HOWARD COUNTY HISTORIC PRESERVATION COMMISSION
ELlicott CITY HISTORIC DISTRICT ■ LAWYERS HILL HISTORIC DISTRICT
3430 Court House Drive ■ Ellicott City, Maryland 21043

September Minutes

Thursday, September 2, 2021; 7:00 p.m.

Figure 4 - Proposed sculpture

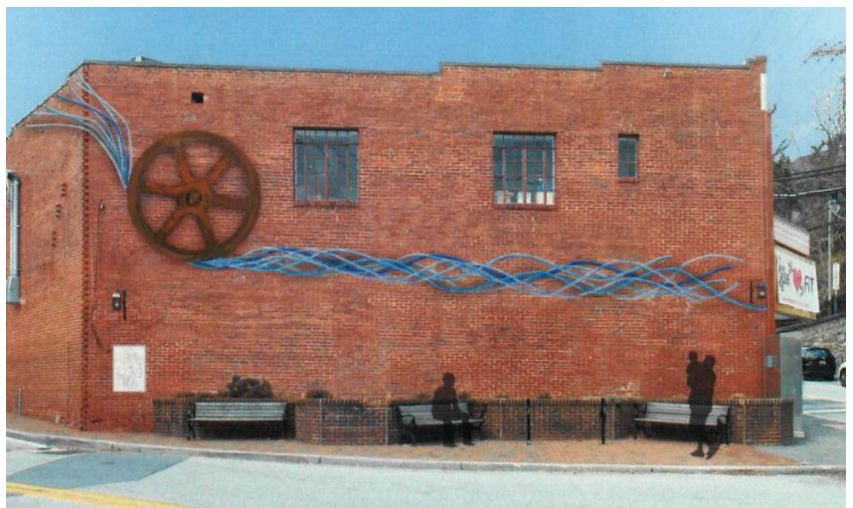
Mr. Reich asked if all of the blue colors on the tubes shown in the application were part of the color palette being utilized. Ms. Egan said those colors are all of the possible hues they would use and explained the artist wants to have the option to use all of the colors, but may not use all of them. Mr. Reich said they all look acceptable.

Mr. Reich asked about the anchoring of the sculpture into the mortar. Ms. Egan confirmed it will be installed into the mortar, not the brick. She said they will make any repairs to the mounting materials as needed.

Figure 6 - Night rendering lighting plan.

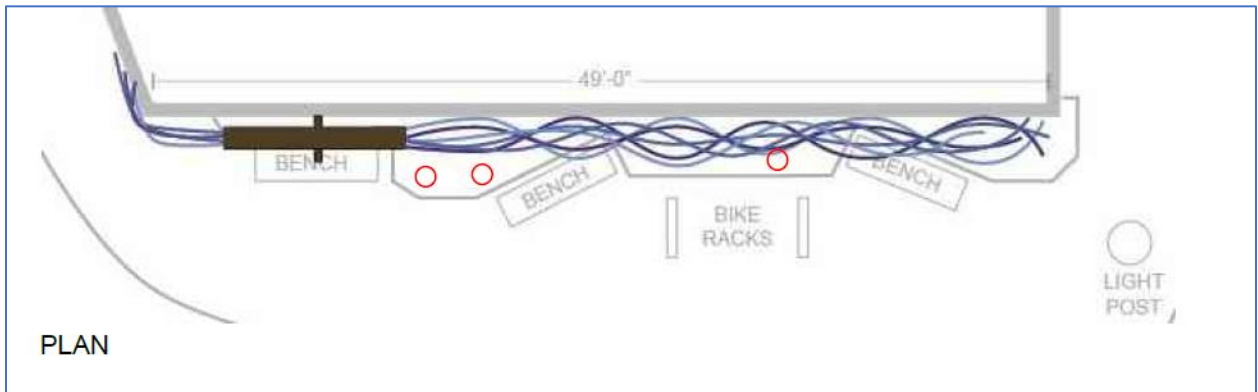
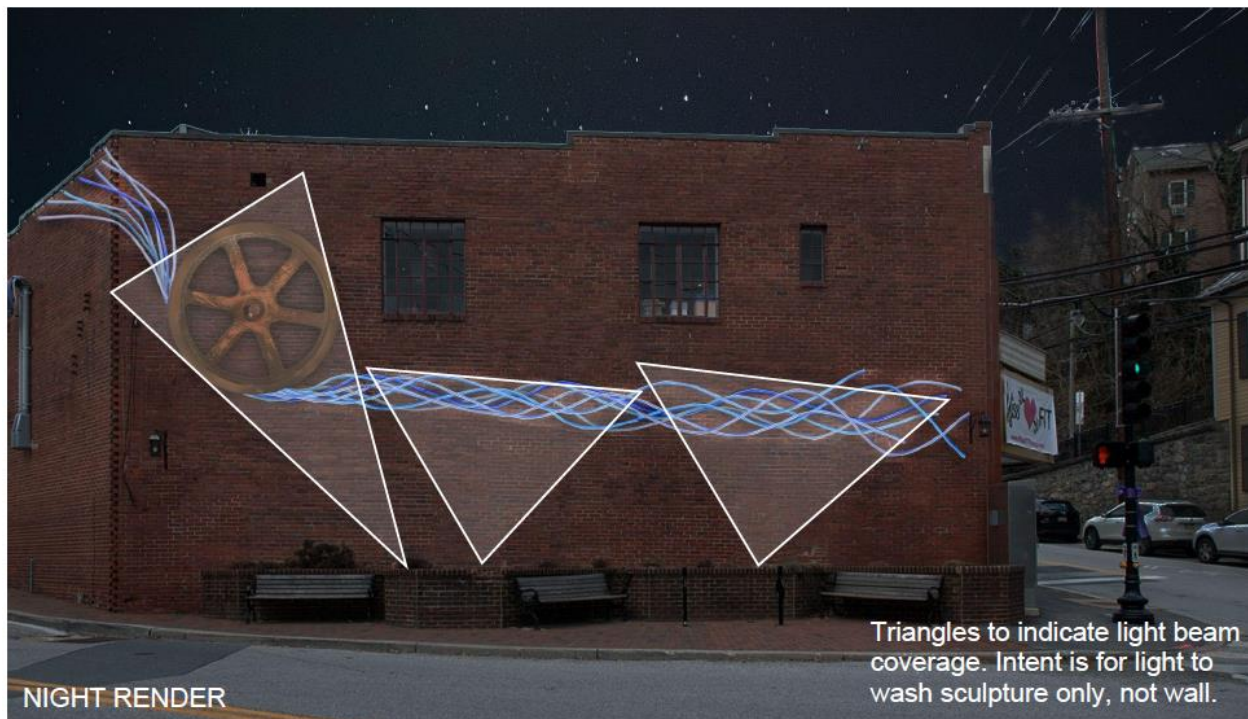
Mr. Reich thanked them for including information about the electronics for the lighting. Ms. Egan said the lights will not shine across the street or into traffic.

Figure 18 - Porch detail.

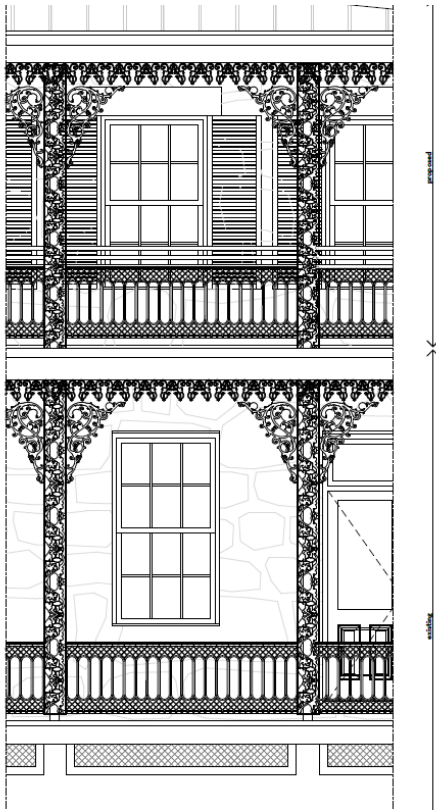
Mr. Reich asked about the need for the tubular steel rails. Mr. Brennan said there is a 42-inch height requirement for Code. Mr. Brennan said their hope is that it will be standoff, single, tubular rail, with vertical pieces at the existing cast iron locations, and will be 1.5 inch in diameter. Mr. Brennan explained the existing cast iron railing is about 30 inches in height, so they want to close the gap of about 12 inches, using horizontal rails. Mr. Reich asked if it will be two or three rails above and behind the cast iron and Mr. Brennan said that was correct. Ms. Zoren referenced sheet A4, and asked if they could increase the height of the second story cast iron railing from 30 inches to 42 inches since they are doing a custom cast iron order. Mr. Brennan said they thought about that, but decided to replicate the original to match the first floor porch. Mr. Brennan said the tubular rails will be steel painted black to match the cast iron.

Figure 21 - Current proposal for approval.

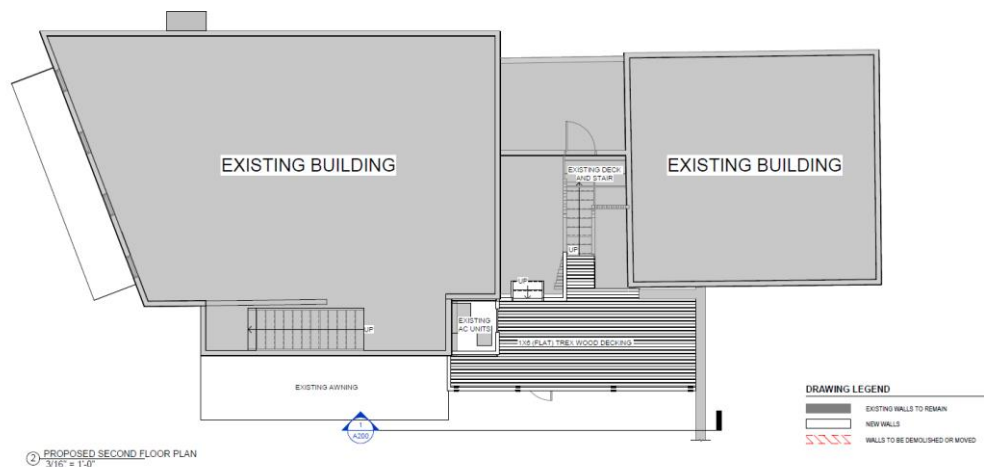
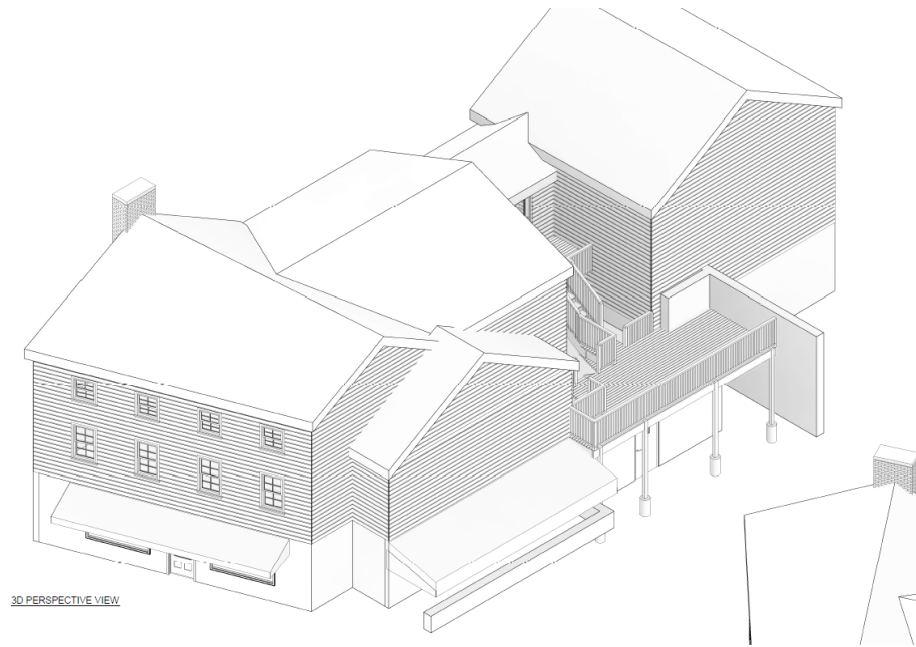
The Applicant proposes to construct a second story rear side deck, using gray composite decking and a black aluminum railing. In Ellicott City, most porch railings are wood, painted white. Black railings are more typically found as first floor wrought iron entry rails, or fencing. The Guidelines provide some leniency for the less visible features of a new porch or deck, such as the decking. The Commission should determine if the proposed composite products comply with the Guidelines.

Mr. Reich said there are details for wood railings on sheet S200, but said the application states black powder coated aluminum railings are proposed. Ms. Johnson said they wanted to use the square black powder coated aluminum railings and described the information contained in the packet.

Mr. Reich asked the Applicant if she would be willing to use a wood fascia on the outside edge framing of the deck, painted to match the building. Ms. Johnson agreed.

Motion: Mr. Reich moved to approve the application as submitted, with the change that the Applicant will use a wood fascia on the outside edge framing of the deck, painted to match the colors on the existing building, and with aluminum rails as submitted, not wood rails shown on construction drawings. Mr. Roth seconded. The motion was unanimously

Figure 28 - Parking area painted green.

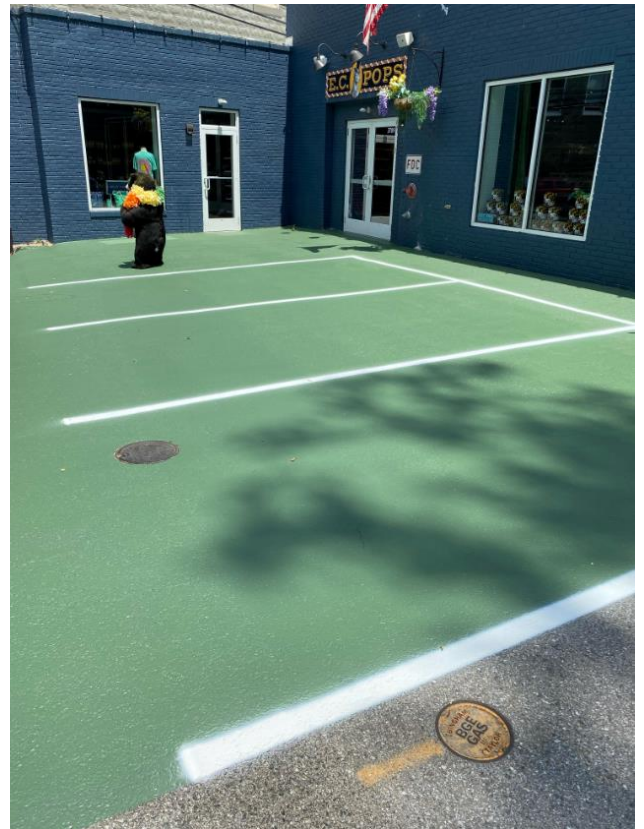
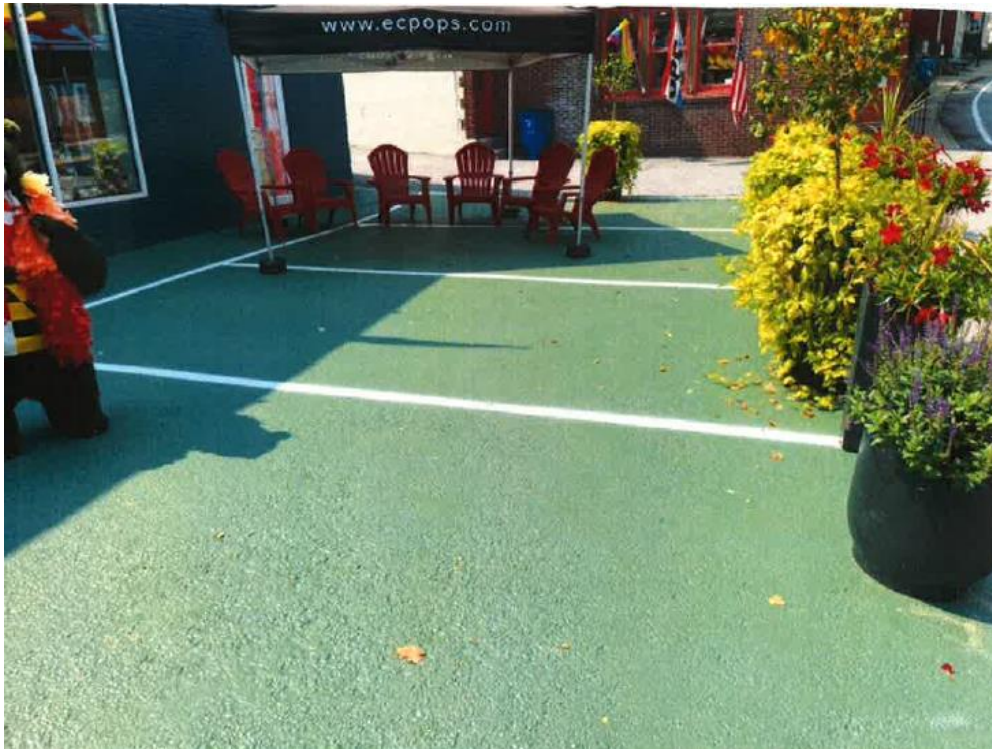
The Guidelines discussion of colors was written for buildings, as it is not typical to paint asphalt parking areas. Exceptions for painting asphalt areas exist only in relation to adding cross walks, ADA spaces, and electric vehicle charging stations. In general, painting of spaces should be reserved for transportation needs and roadway design.

The Guidelines specifically recommend against bright colors except for small details. The use on the parking lot represents a large area, not a small detail. The tennis court green color that was used is comparable to a grass green and as stated in the guideline 6.N.3, is not a historically appropriate color. There are no other painted parking areas in the historic district.

Historically, asphalt parking areas are black, and fade to a gray, until the time when they are recoated again. The Guidelines allow for the recoating or blacktopping of an asphalt area or existing gravel driveway to be Routine Maintenance, as it is the expected treatment of such an area.

Mr. Roth said the green color is not appropriate and does not comply with the Guidelines. He said the color is also used to delineate bike lanes and using it for other purposes can lessen the effectiveness when needed for bike lanes. He does not think they should consider any street furniture or planters in this meeting without sufficient public notice. Mr. Roth thinks those items should be submitted for approval with the intent to leave out every night.
